# CHABOT-LAS POSITAS COMMUNITY COLLEGE DISTRICT PURCHASING DEPARTMENT

## Addendum No. 2

### REQUEST FOR PROPOSAL BID: B23/24-06 Erosion Control Project at Las Positas College

NO PART OF THIS DOCUMENT MAY BE REPRODUCED IN ANY FORM INCLUDING PHOTOCOPY, RECORDING OR ANY INFORMATION RETRIEVABLE AND STORAGE SYSTEM, WITHOUT PERMISSION IN WRITING FROM SANDIS.

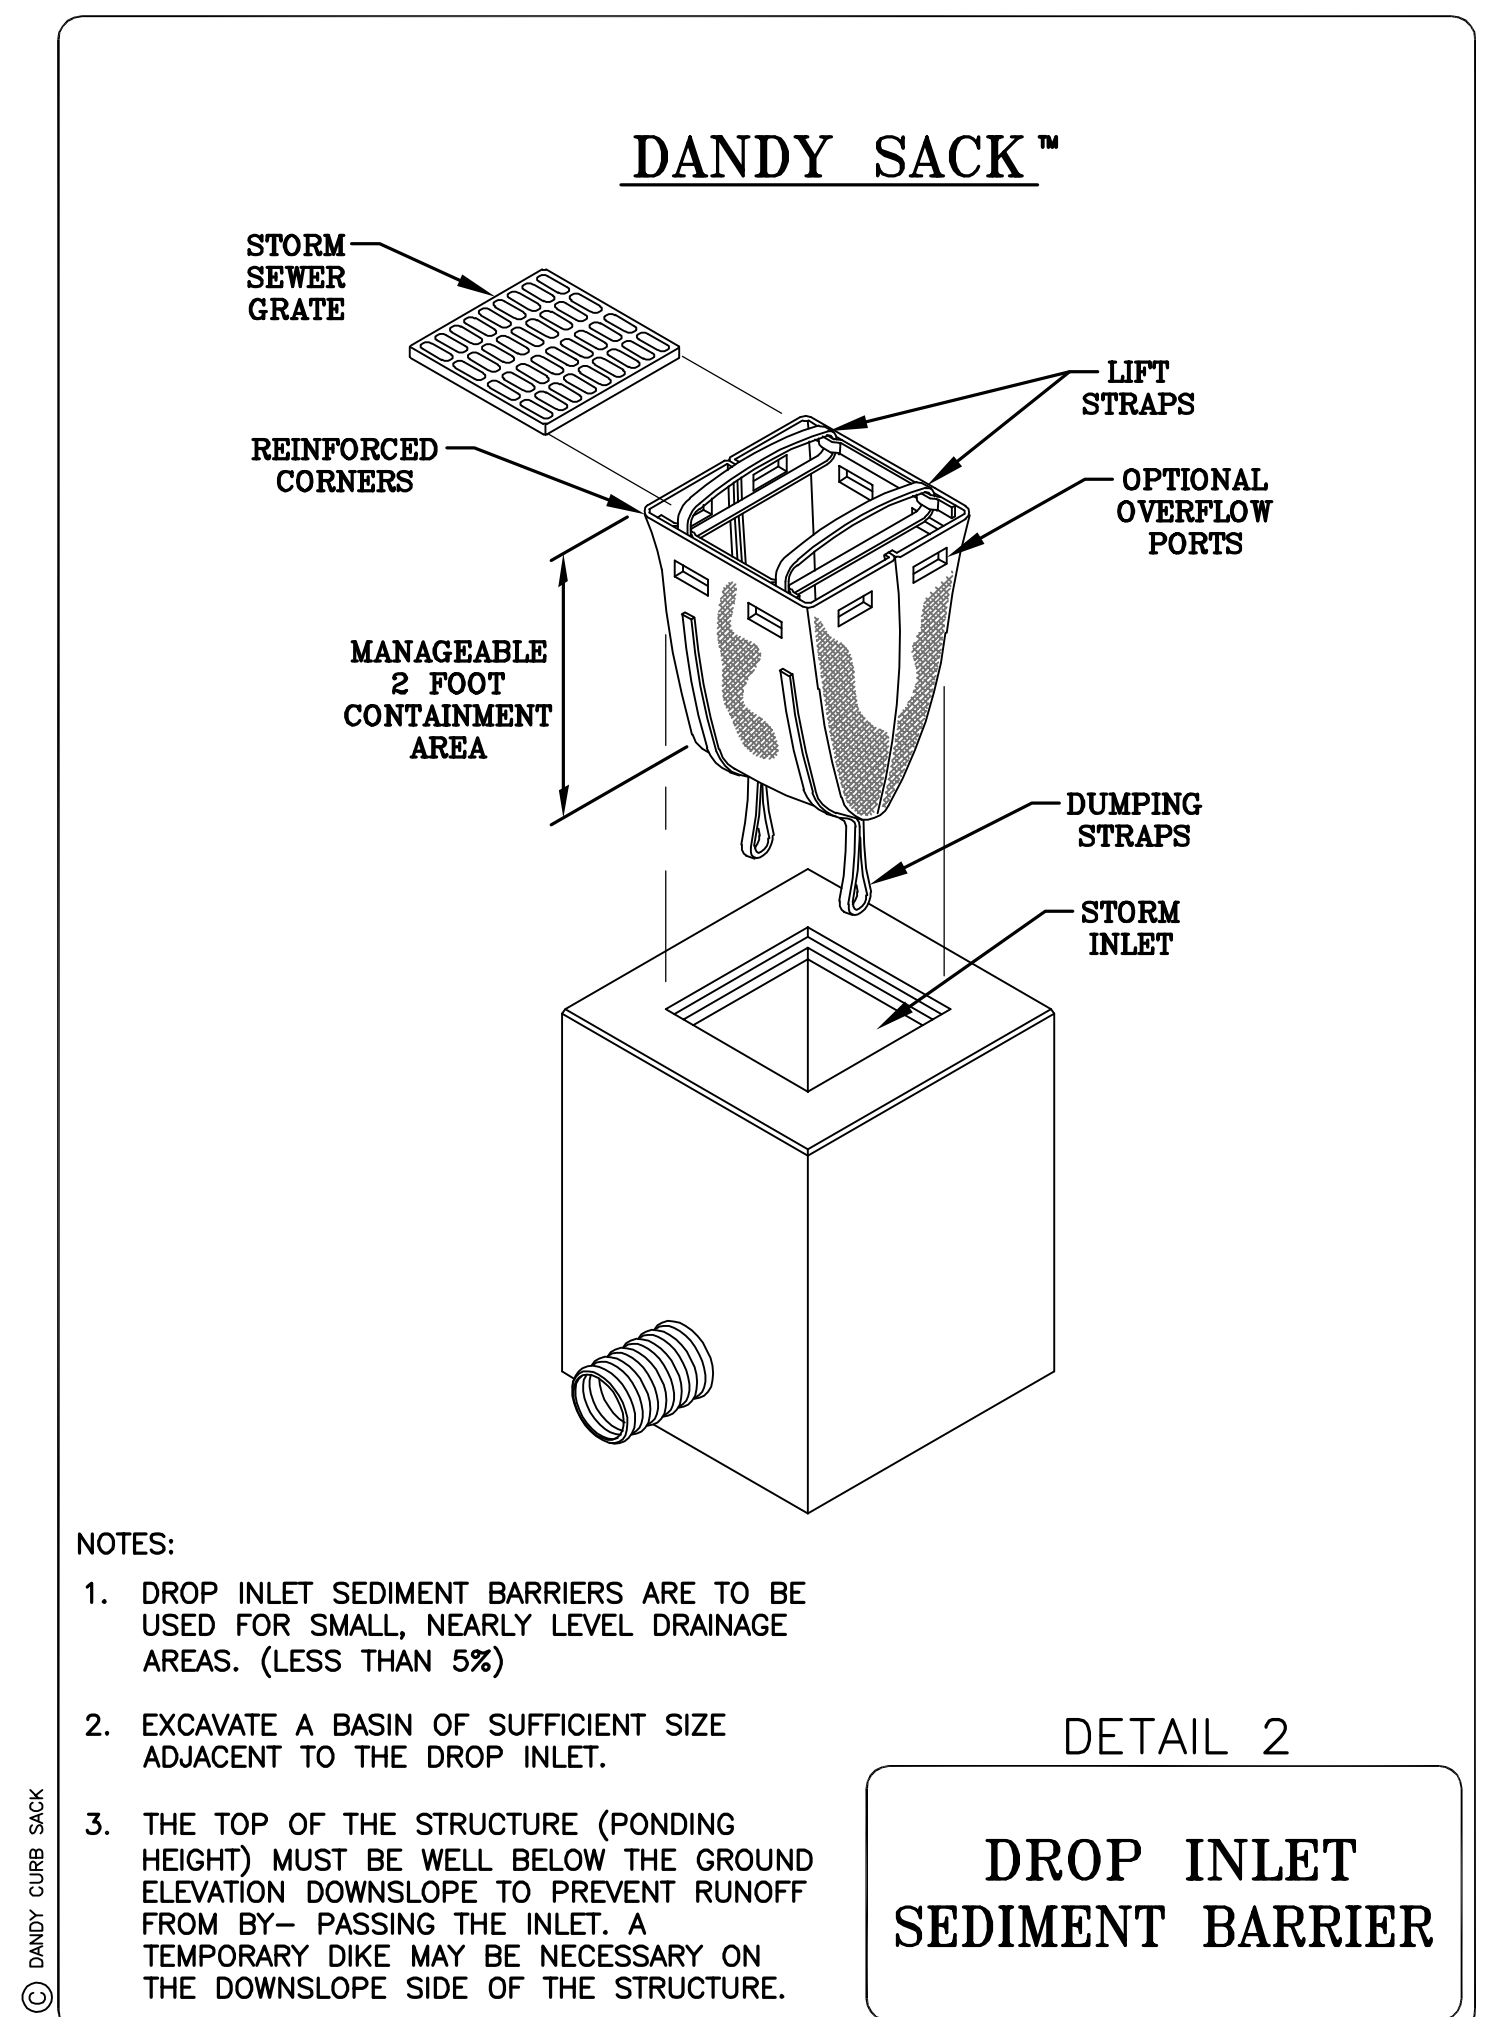
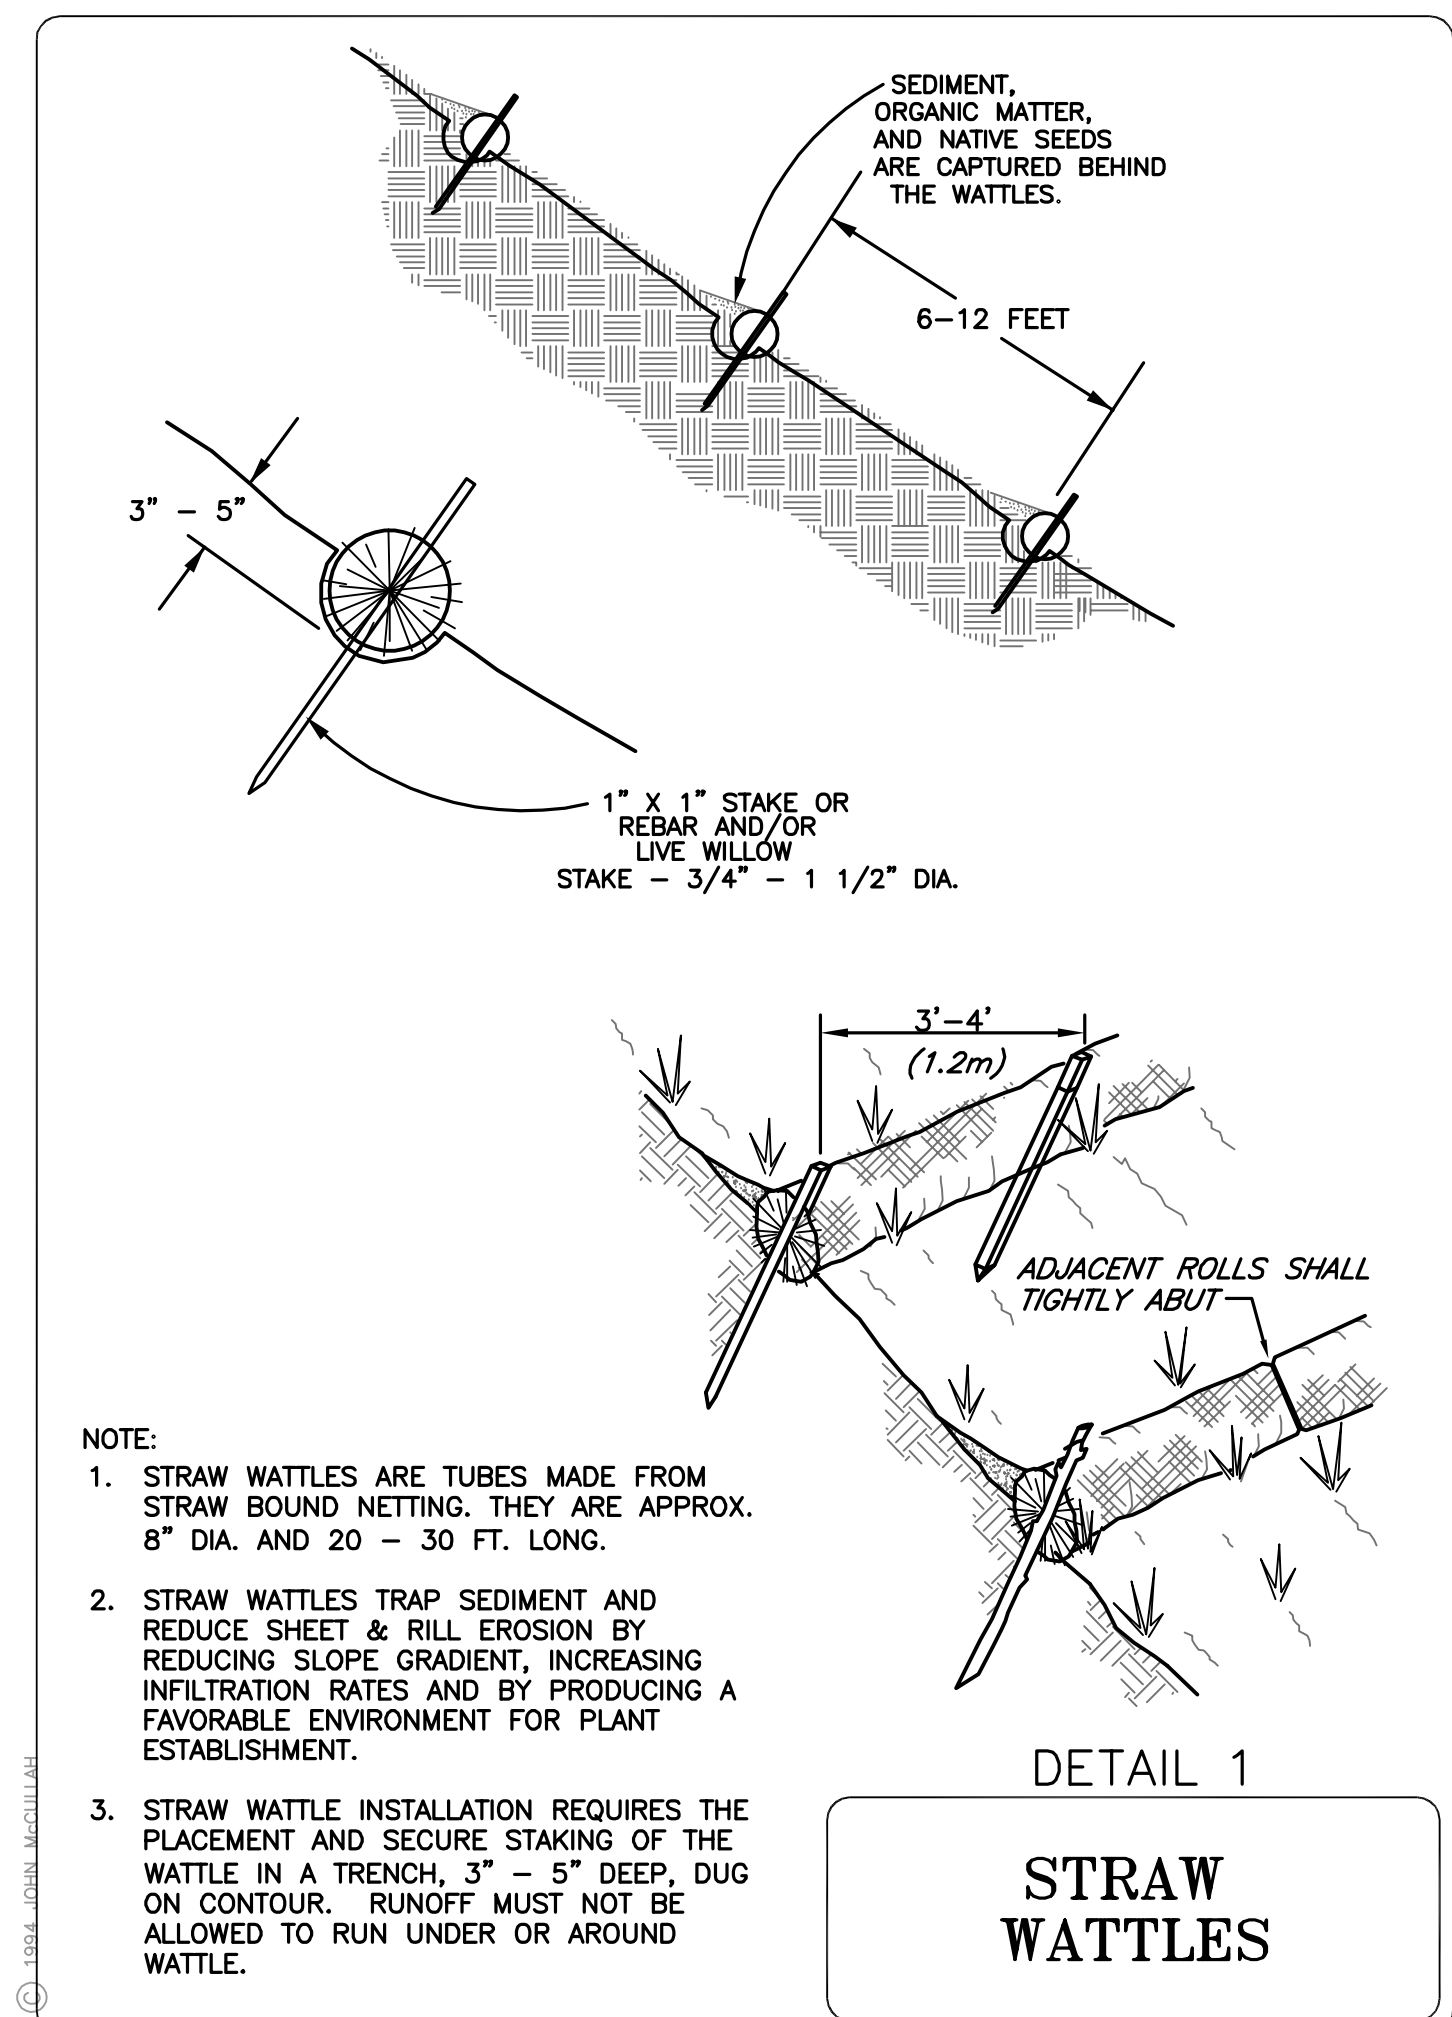
**Question No. 22:** The shading for hydroseed areas is a "+" sign. In my opinion, there are 3 different styles of "+" on these sheets. Two of which cover the gravel roads we are to install per the plans. Can you please clarify the actual areas to be hydroseeded?

**RESPONSE:** Gravel roads are not intended to be hydroseeded. See revised sheets C5.0 and C5.1 attached to this addenda 2.
